FAWN GROVE AT SUNSET LAKES

an Addition to Wichita, Sedgwick County, Kansas

RE: SUB 2003-120 -- Final Plat of Fawn Grove at Sunset Lakes Addition

CASE NUMBER: SUB 2003-120 -- FAWN GROVE AT SUNSET LAKES ADDITION

FAWN GROVE AT SUNSET LAKES

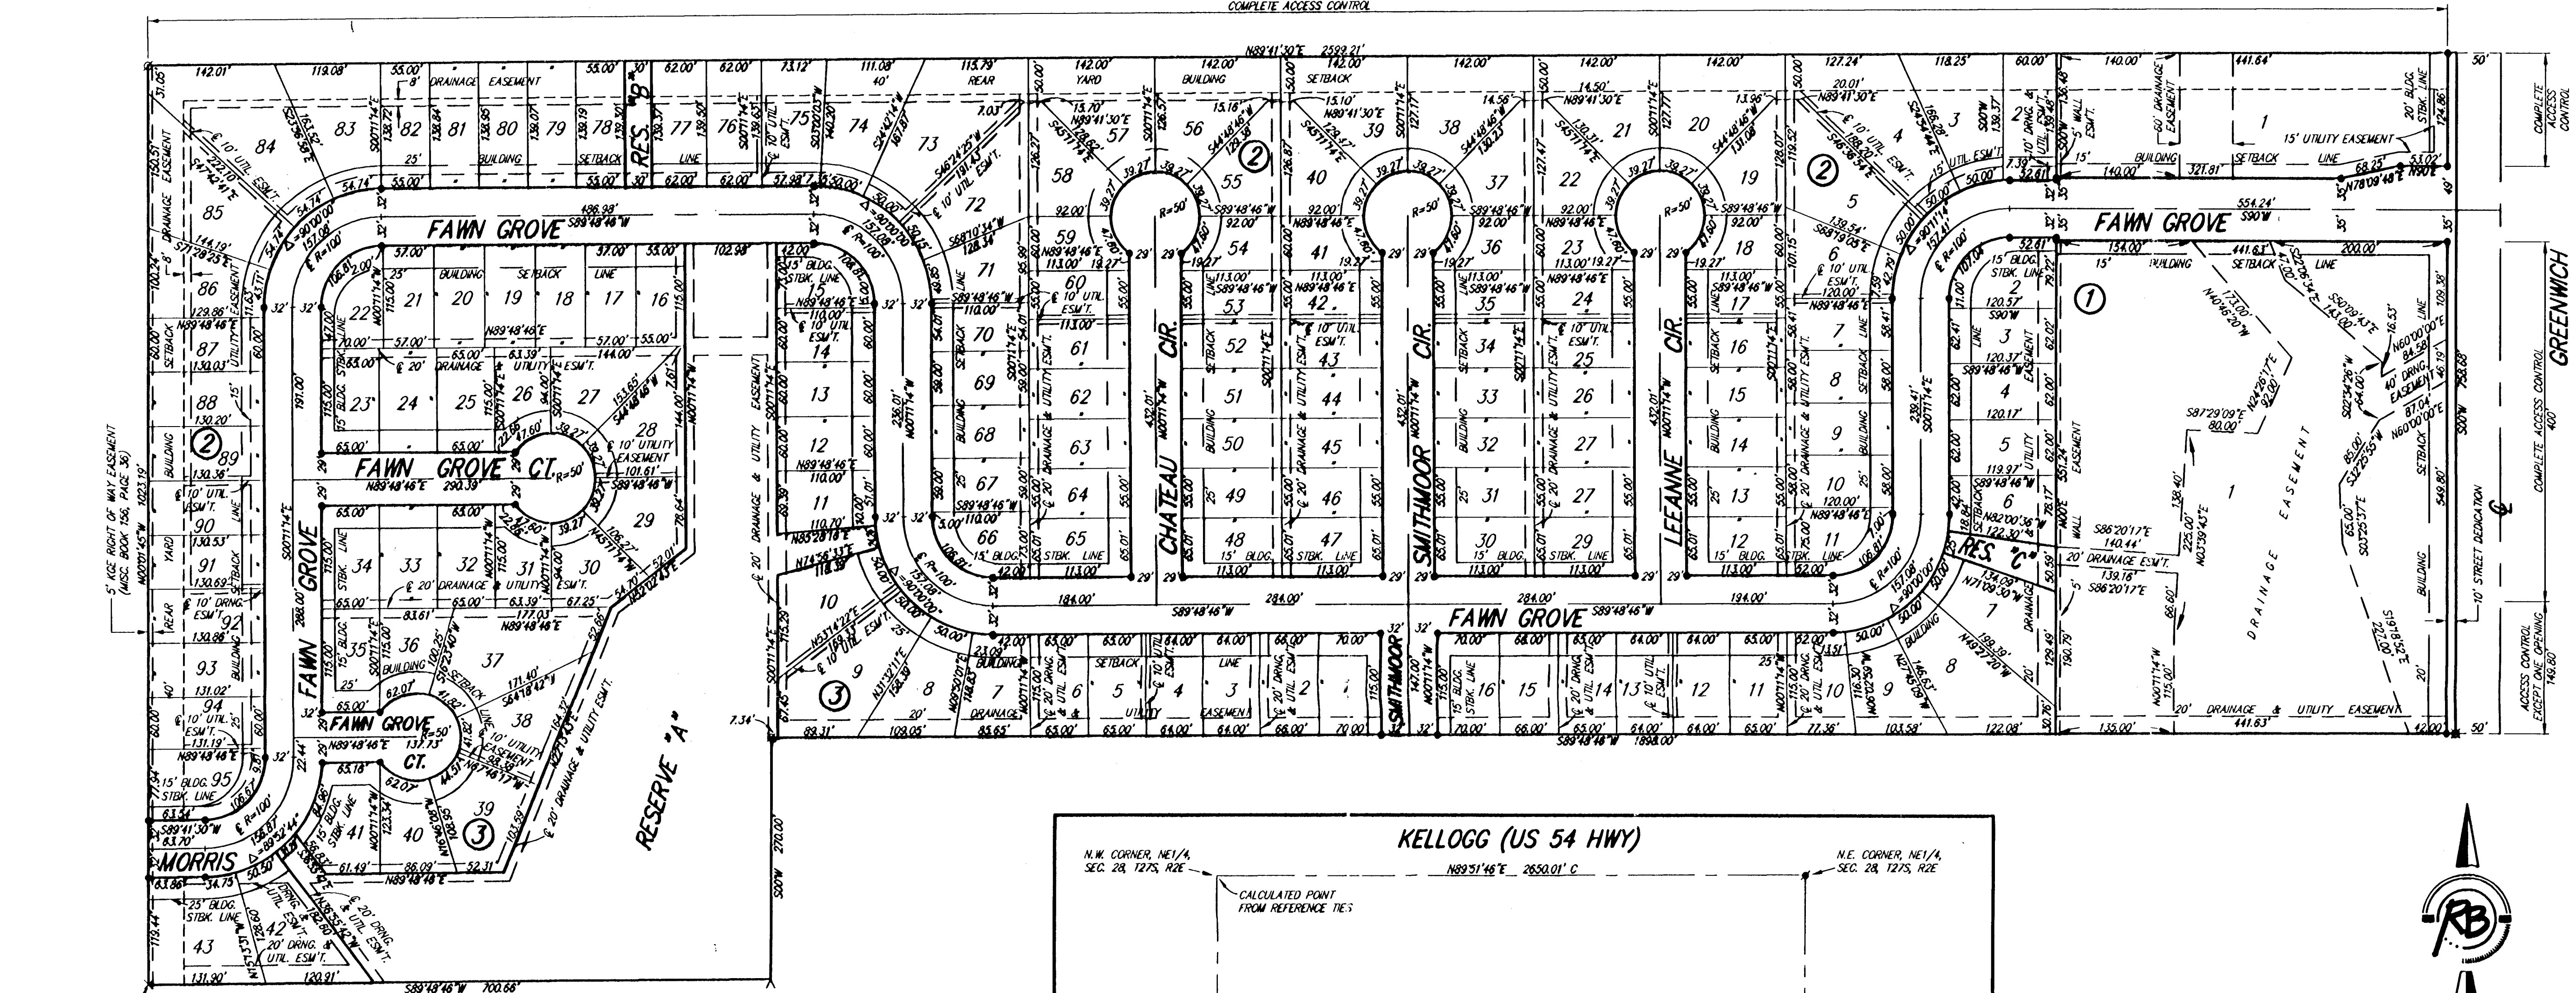
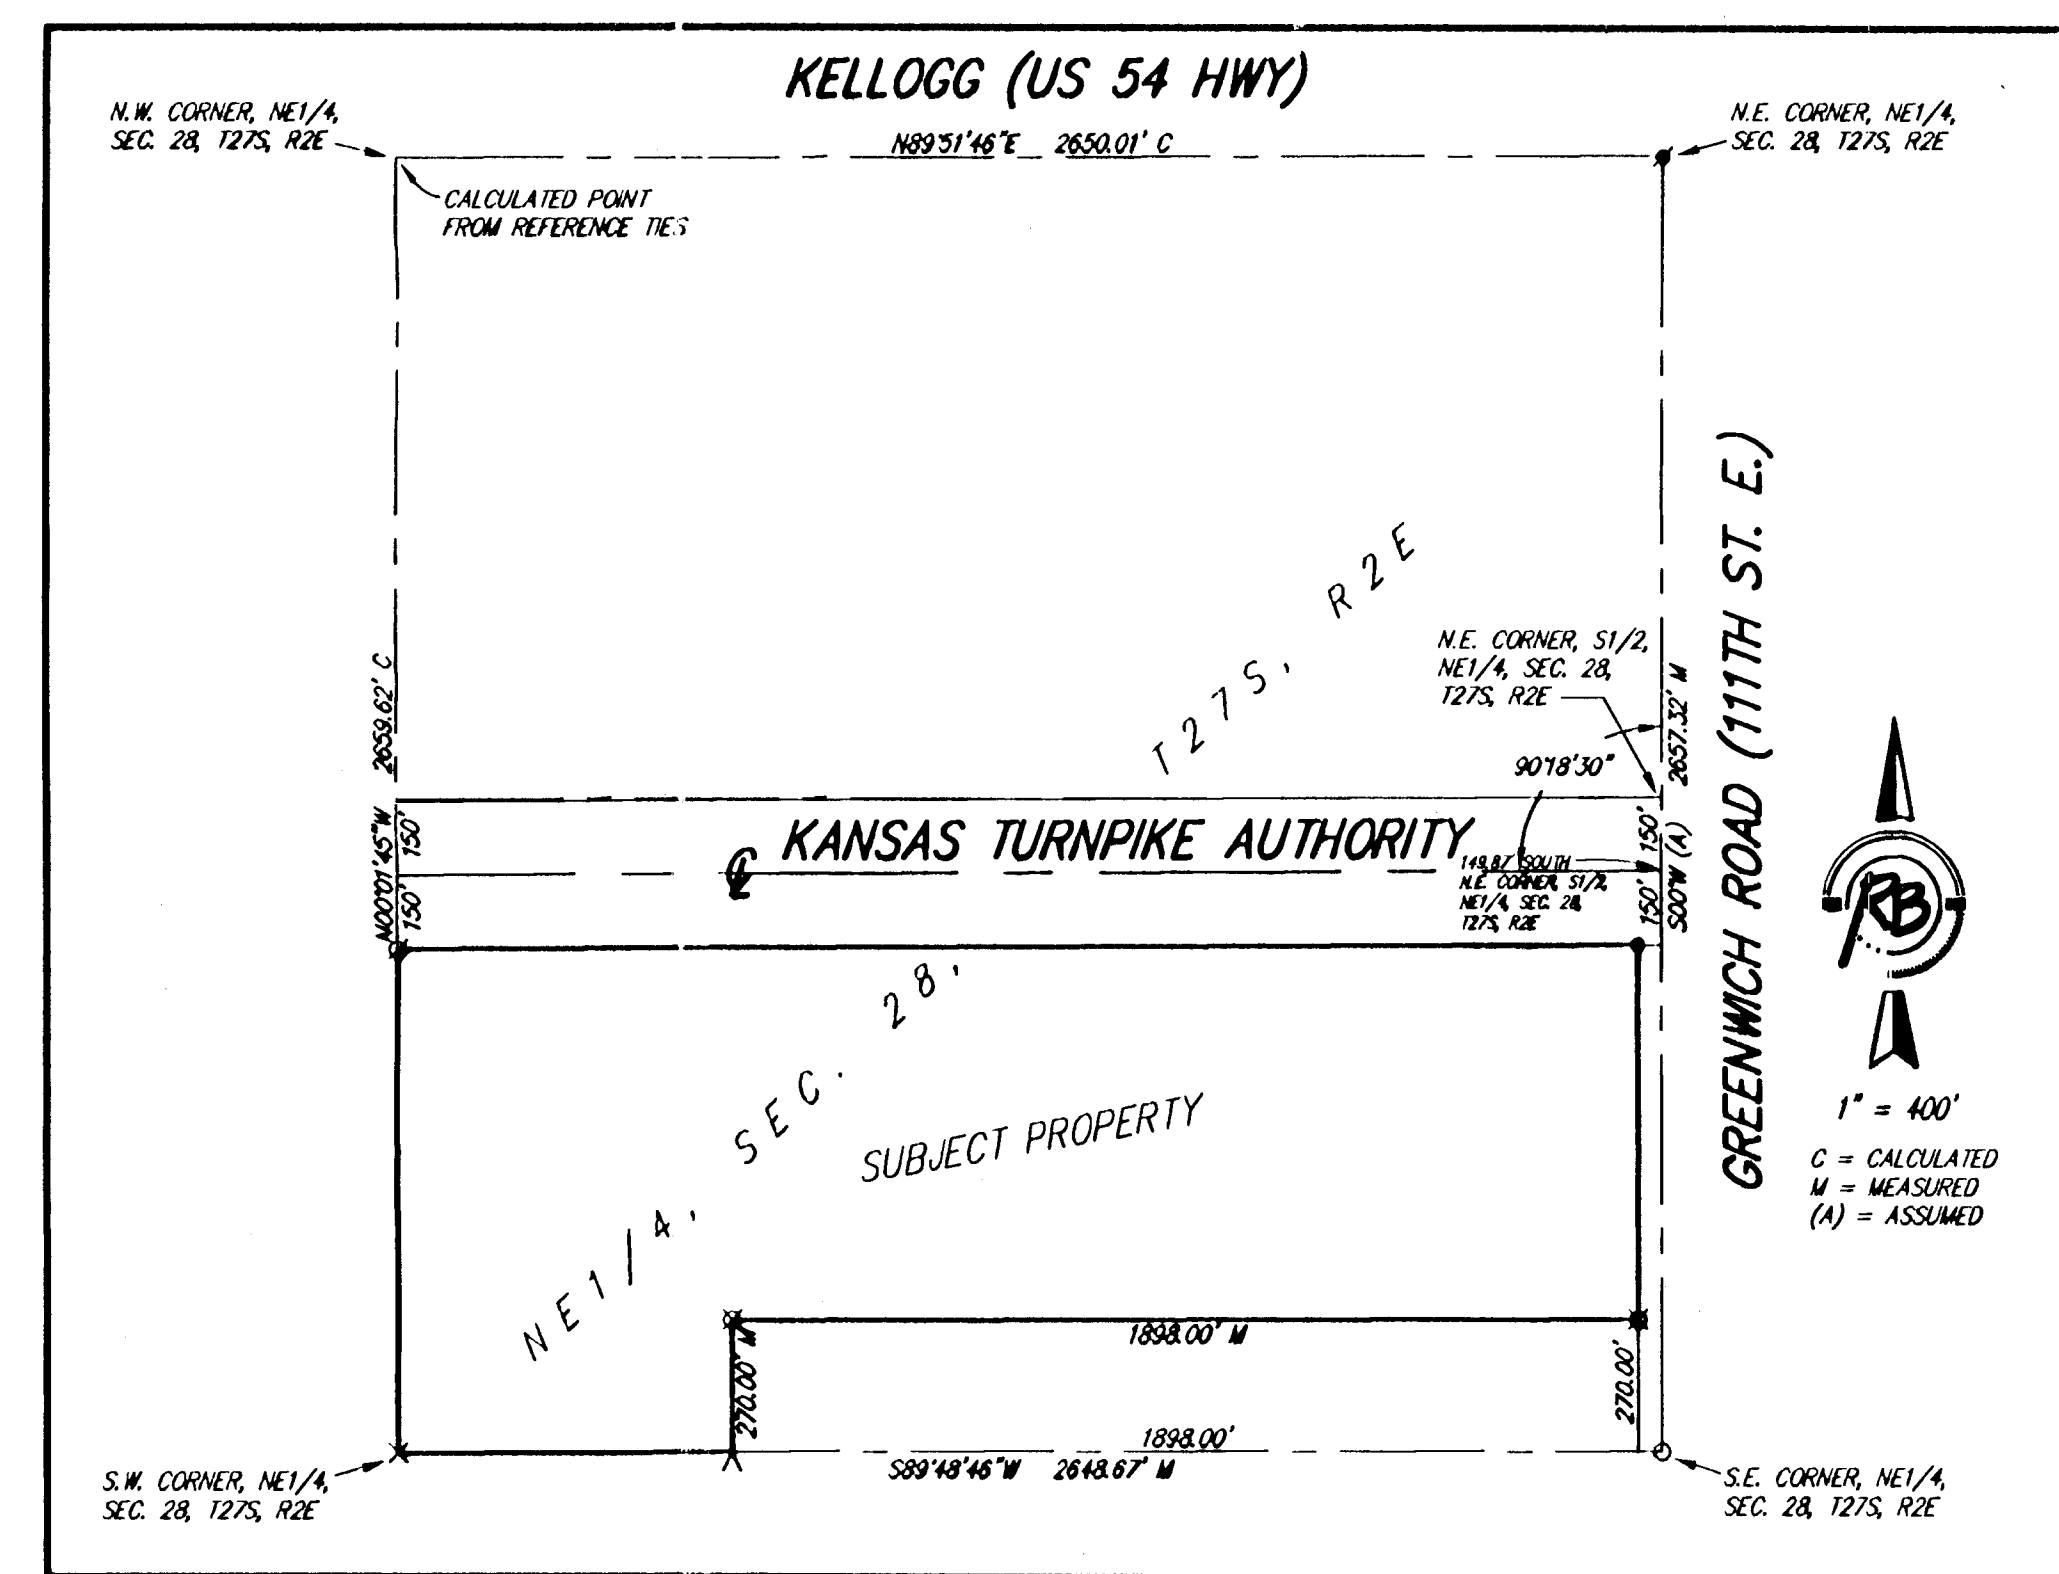
- A. This plat will be subject to approval of the associated zone change and any related conditions of such a change.
- B. The applicant shall guarantee the extension of sanitary sewer and City water to serve the lots being platted.
- C. If improvements are guaranteed by petition, a notarized certificate listing the petitions shall be submitted to the Planning Department for recording.
- D. City/County Engineering needs to comment on the status of the applicant's drainage plan. Stormwater Management has advised that the drainage plan must be in compliance with the drainage study currently being prepared for this area.
- E. The plat proposes one access opening along Greenwich. Access controls are approved.
- F. A 70-foot right-of-way for a commercial street is needed along Fawn Grove from Greenwich to the west line of Lot 1, Block 1 tapering to a 64-ft right-of-way.

- G. Traffic Engineering has requested the right-of-way width be increased to 64 feet for the street stub to the south.

- I. It is recommended that Reserve A be extended to the street by access easements or by narrow strips of Reserve between the lots to increase its accessibility and usefulness for all homeowners in the Addition.

- M. Block 1 west of Smithmoor should be labeled as Block 3.
- N. Traffic Engineering has requested a petition for left turn lanes.
- O. Morris does not line up with Morris as platted in Harrison Park 2nd Addition by 1.48 feet.

The right-of-way has been platted as requested.

The right-of-way width has been platted as requested.

The Applicant has provided an additional connection from the street to the Reserve as requested.
